**ADDENDUM NUMBER: ONE**

**PROJECT:** Pamlico County EOC / 911 Dispatch  
Bayboro, North Carolina  
Project Number 18068

**DATE:** October 9, 2024

Sheet Title: **GRADING and DRAINAGE**

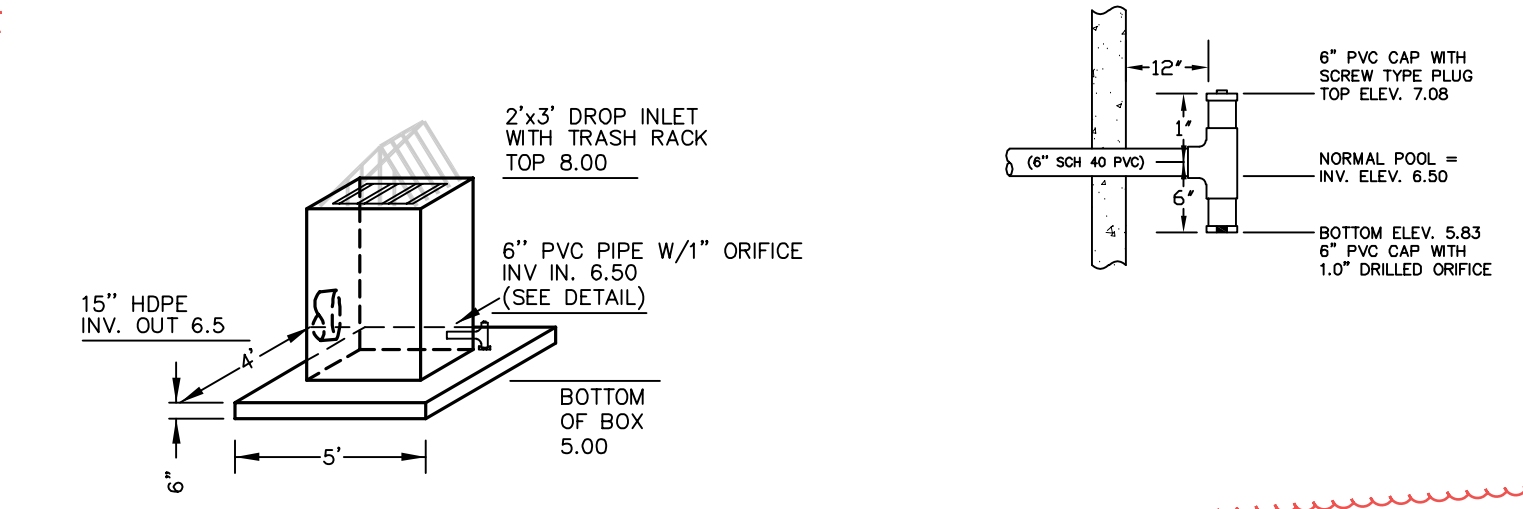
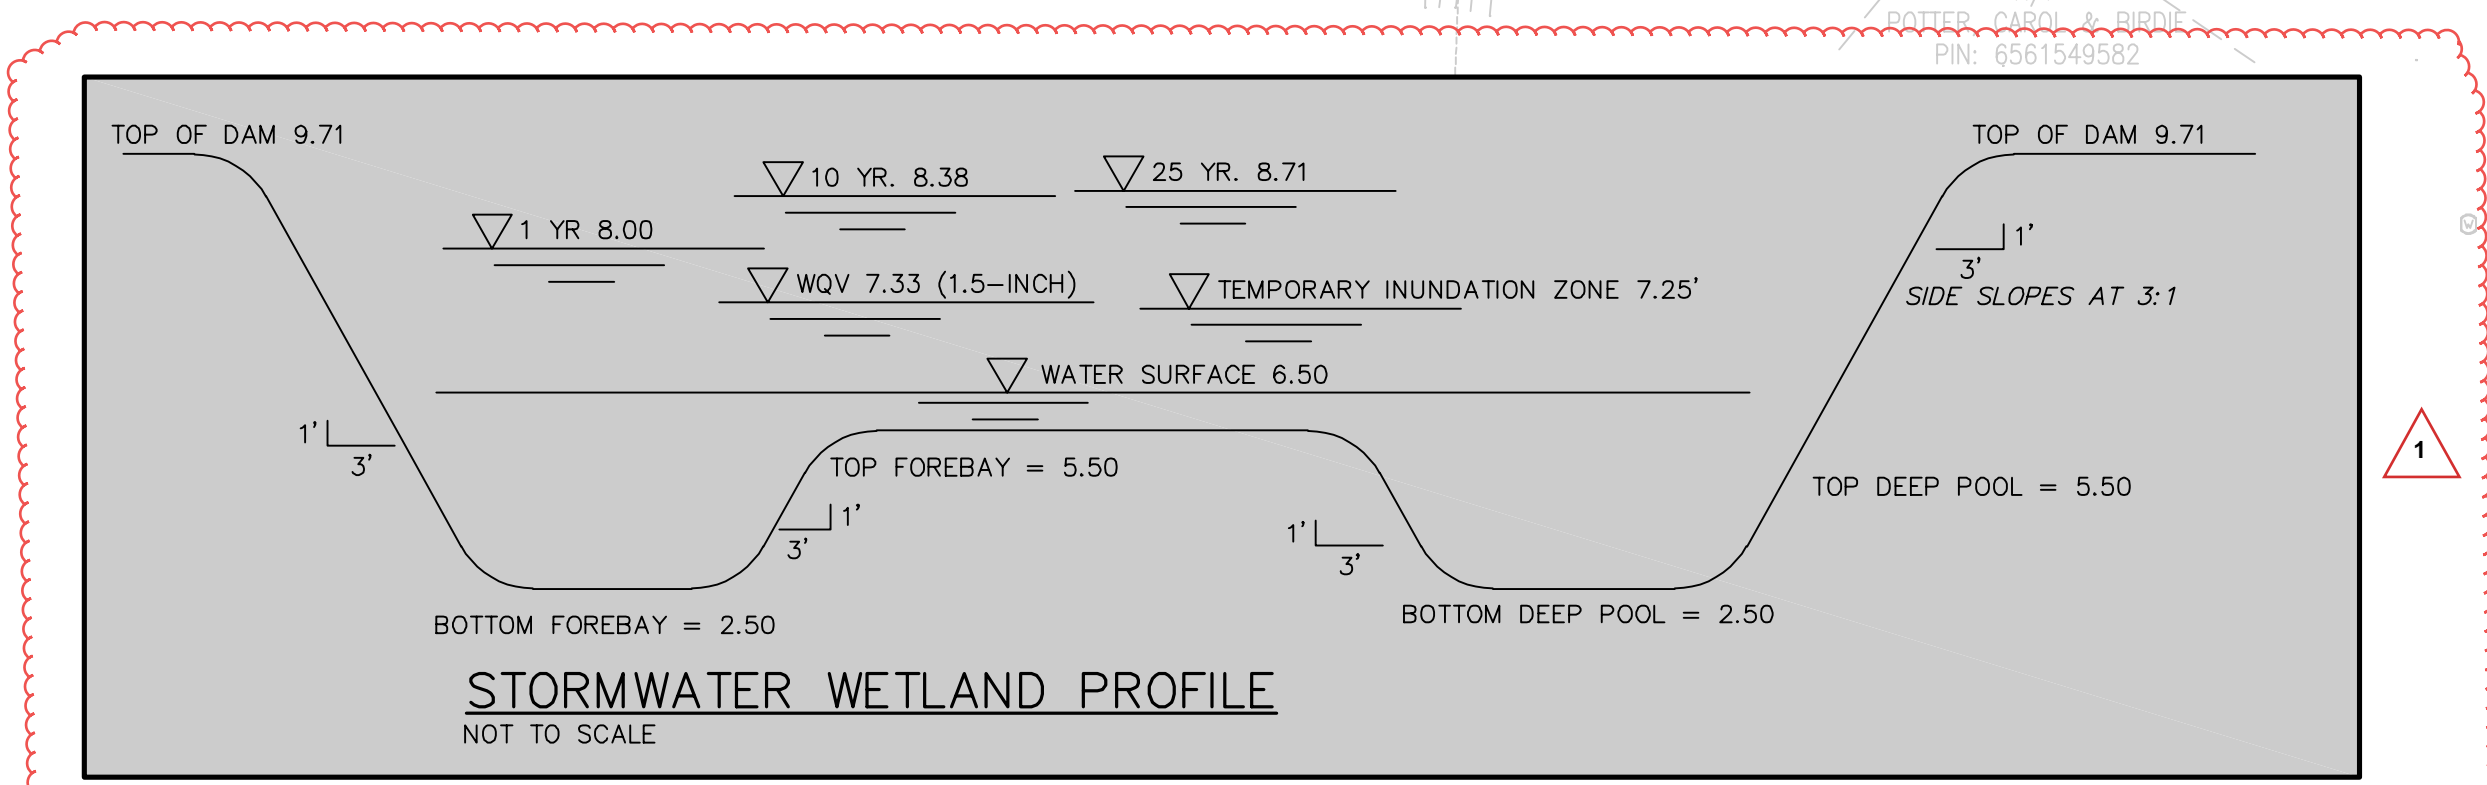
**Item 1 Change:**     **Sheet CE0.3 – Grading and Drainage – Stormwater Retention**  
Replace Sheet CE0.3 in its entirety. Revisions were made to the retention pond. Revisions are clouded.

Date	Project No.
09.12.24	<b>24017</b>
Drawn By	Sheet No.
JS/JAR	<b>A1.1</b>
Checked By	Sheet Title
DG	FIRST FLOOR PLAN

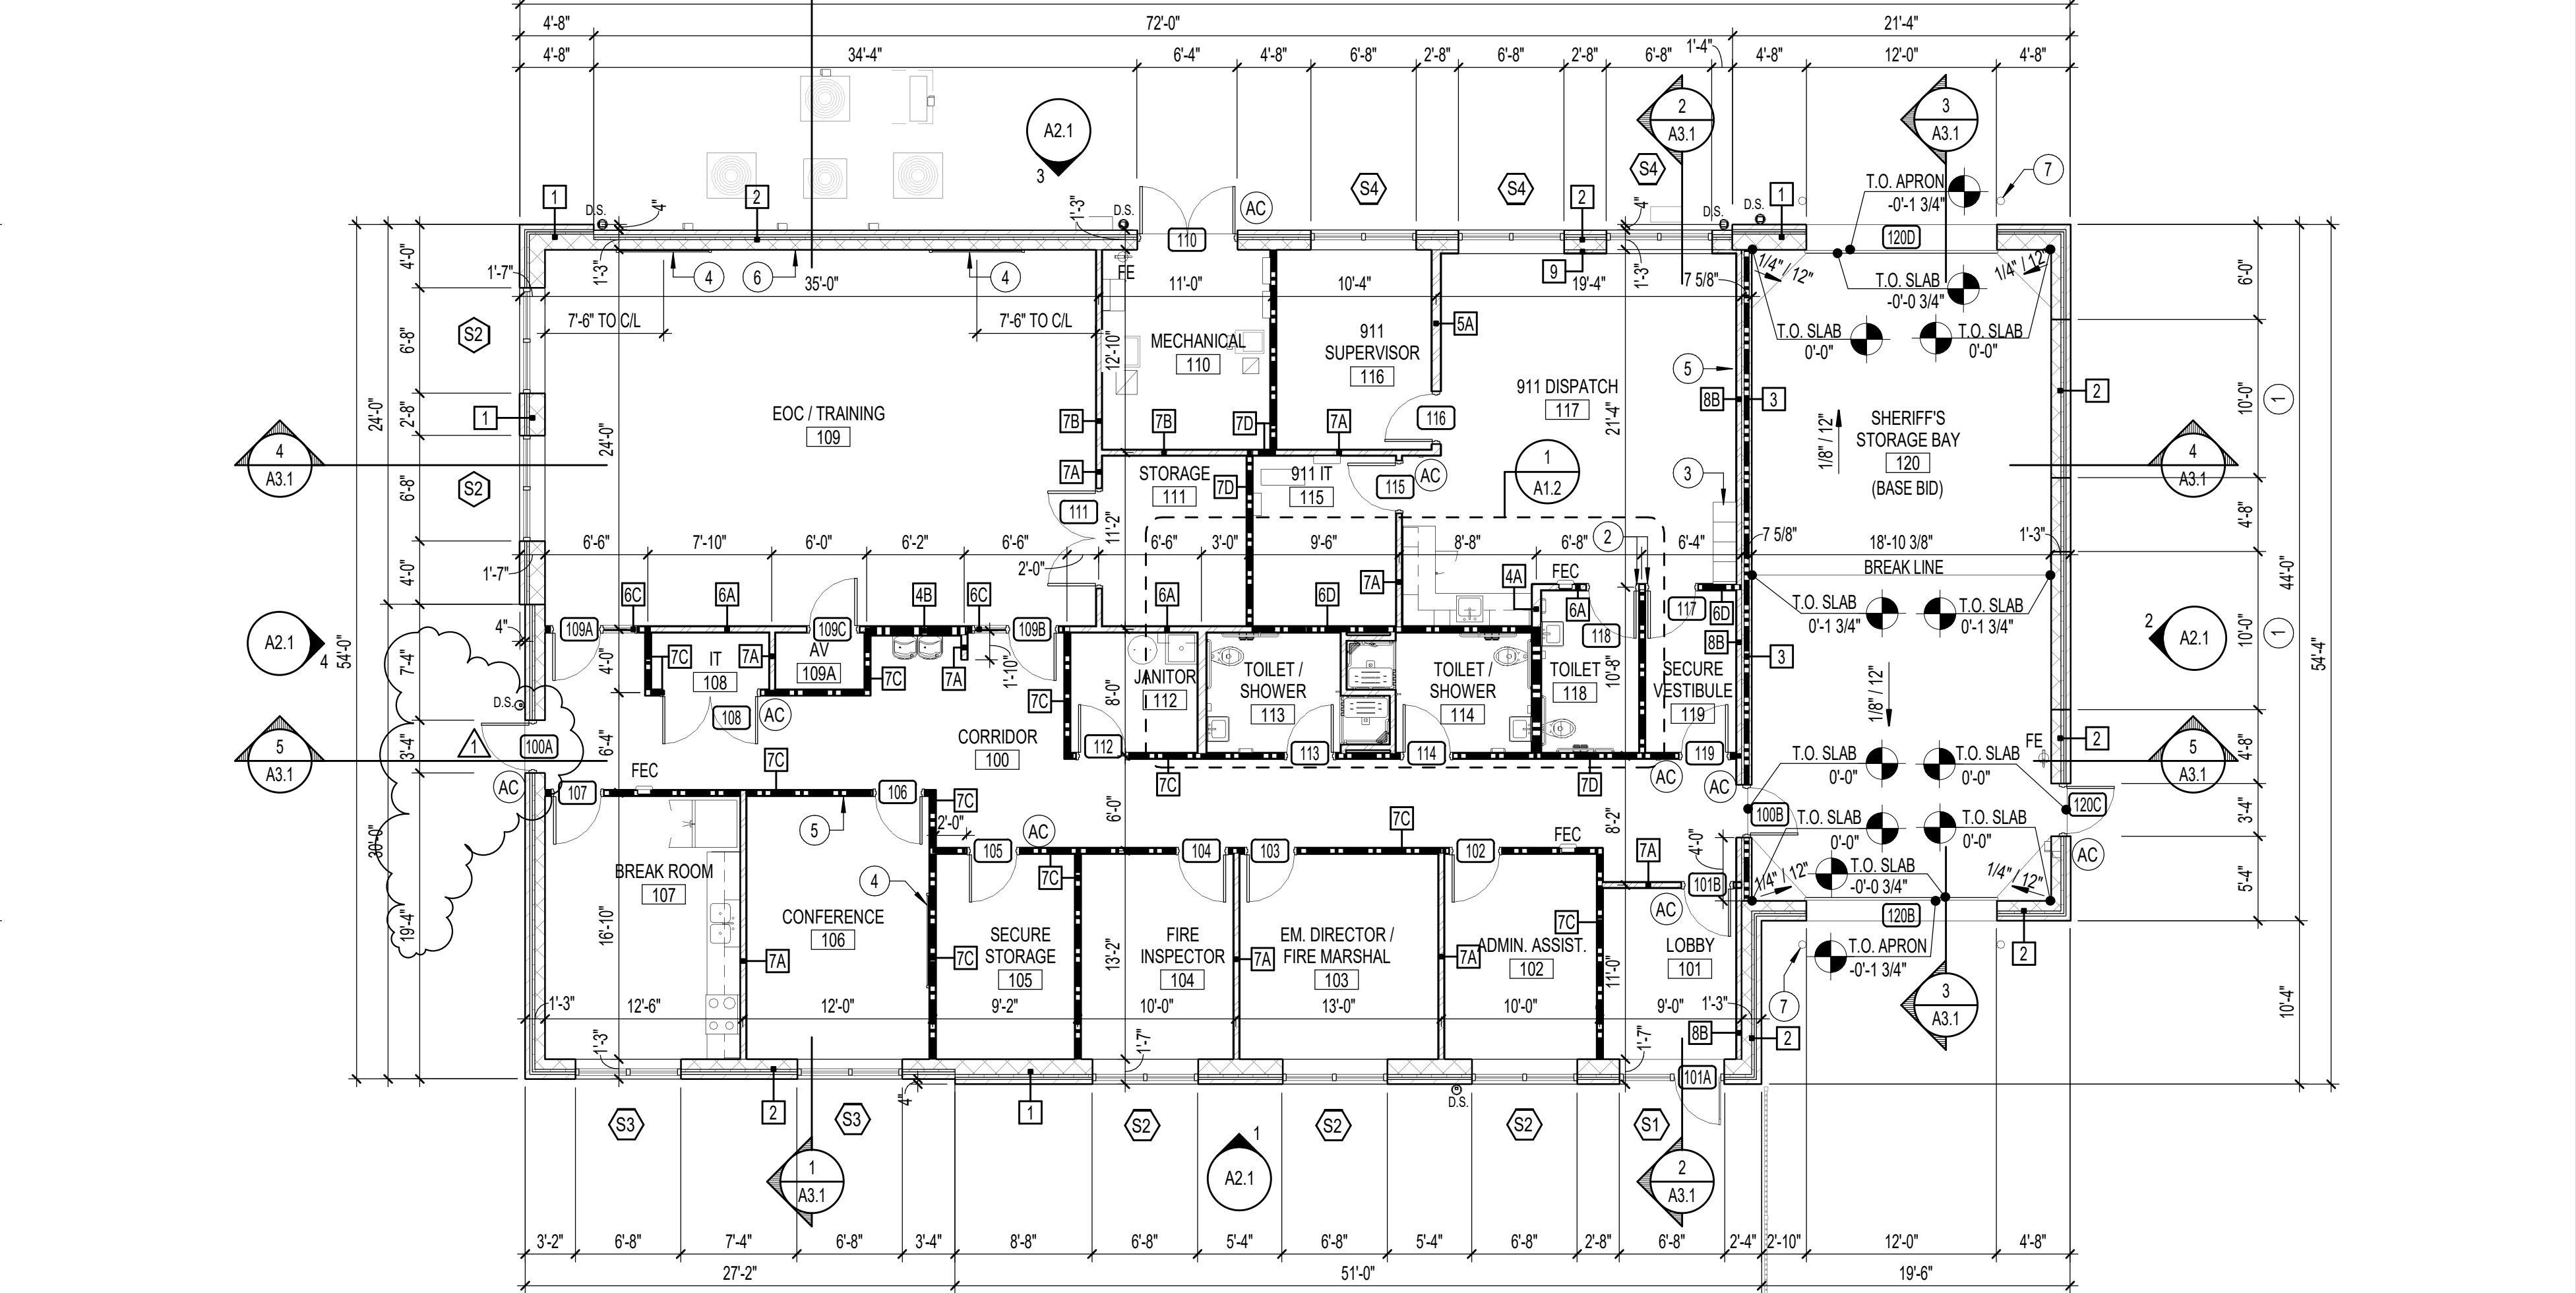
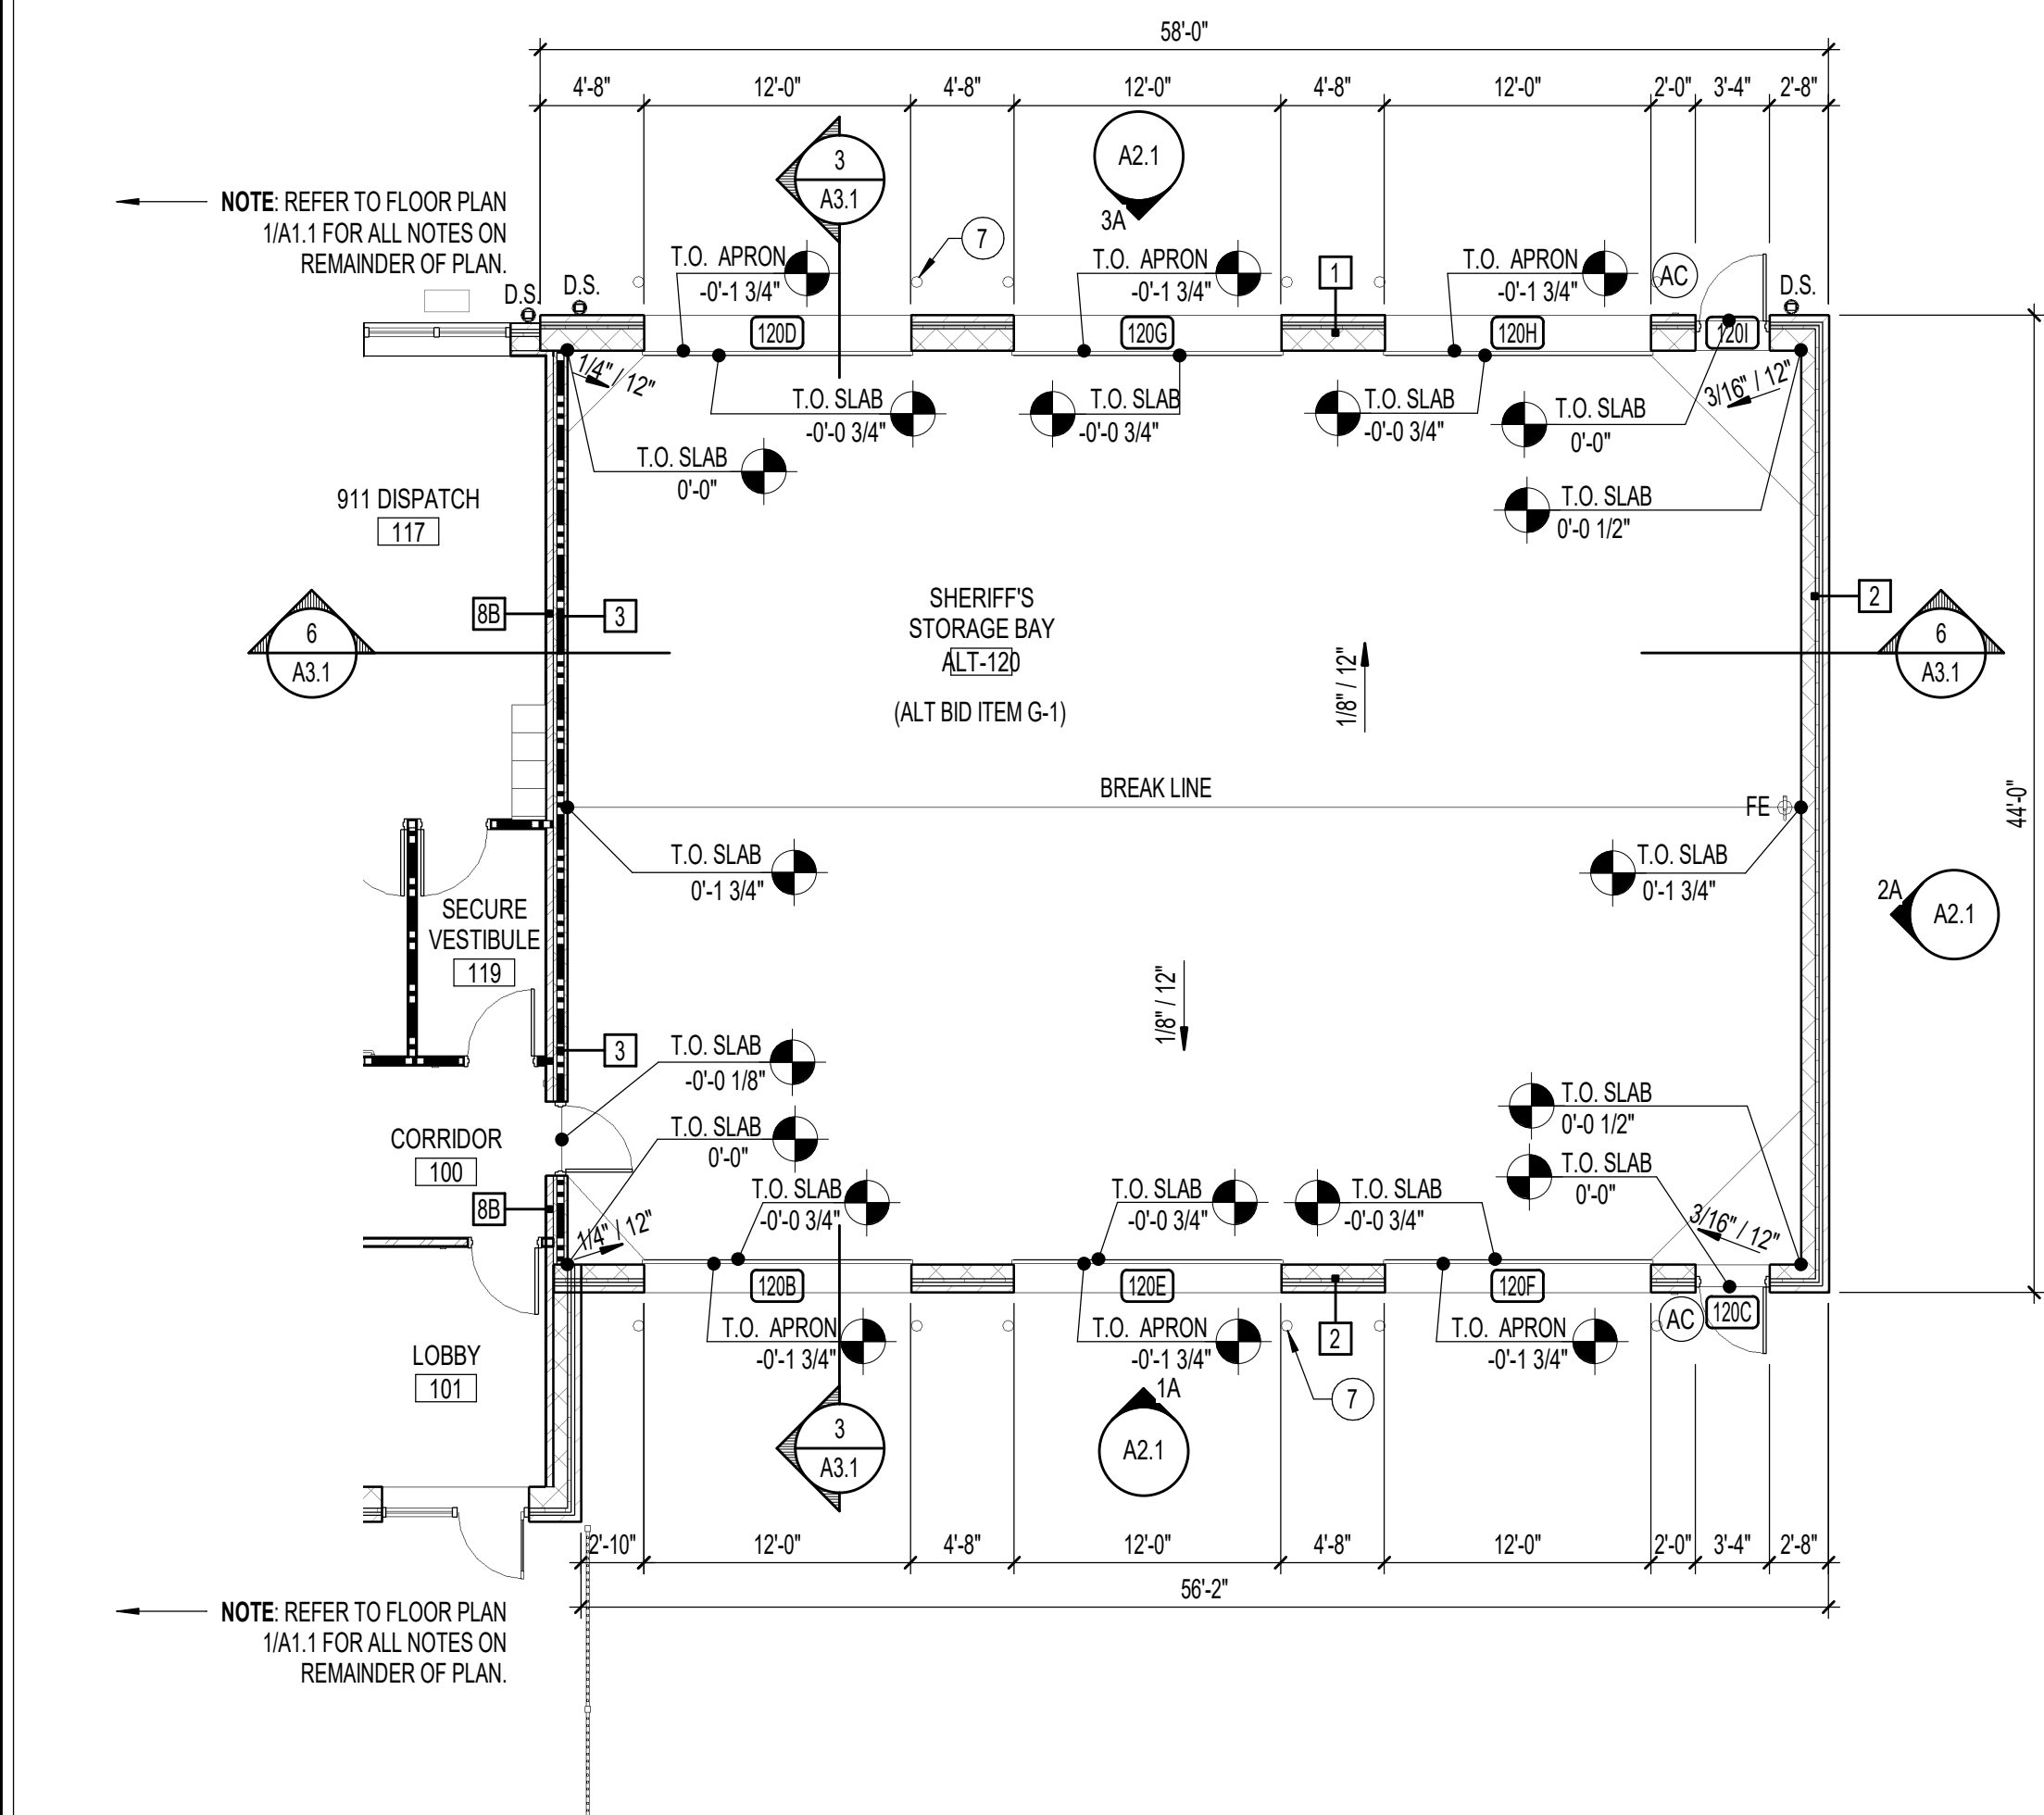
**Item 3 Change:**     **Sheet A1.1 – Floor Plan & Sheet A1.4 – Reflected Ceiling Plan – Door Swing**  
Replace Sheet A1.1 – Floor Plan & Sheet A1.4 – Reflected Ceiling Plan in their entirety. Change swing of door 100A as shown. Door and architectural canopy have been moved 8” to allow for enough clearance at side of door. Move adjacent access control, light switch, and exterior sconce light fixture to latch side of door. Move the downspout for the canopy above to the hinge side of door.
